**RE: Response to BWC Bogastow Brook, LLC BESS Project Stormwater Design Peer Review #1
Proposed Battery Energy Storage System – 600 Central Street, Holliston, MA**

TRC is pleased to provide the following responses to the engineering peer review letter, dated October 24, 2022 and prepared by CMG Environmental, Inc. The letter provided comments on the stormwater design for the proposed battery energy storage system to be located at 600 Central Street in Holliston, Massachusetts. The stormwater design is presented in the Issued-For-Permitting Civil Design Drawing Set (Drawings) and Stormwater Management Report, dated August 2022 and prepared by TRC. Additional fieldwork, including soil testing and surveying of the flood elevation, is currently underway in response to the peer review comments. The proposed project design may need to be adjusted based on the findings of the soil testing and surveying. Therefore, the updated Drawings and Stormwater Management Report will be submitted after the results of the fieldwork are received.

Existing Conditions Surveying Plan

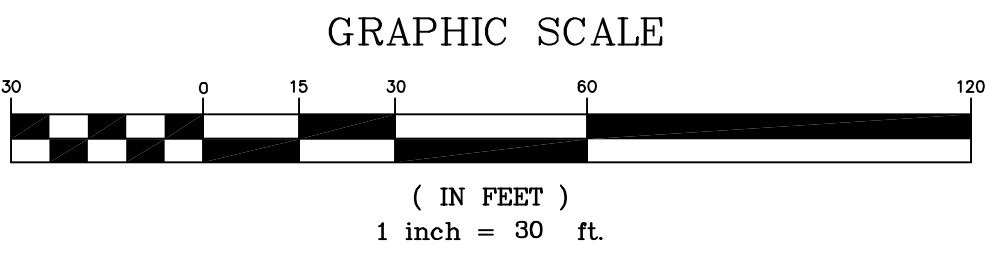
1. *"Existing Conditions Plan" Sheet C1.00 is not stamped by a Licensed State of Massachusetts Land Surveyor. Sheet G1.01 references an Existing Conditions Plan prepared by Land Planning, dated January 19, 2022, however it is not provided.*

Response: An Existing Conditions Plan, prepared by Land Planning and stamped by a Licensed State of Massachusetts Land Surveyor, is provided as **Attachment 1**.
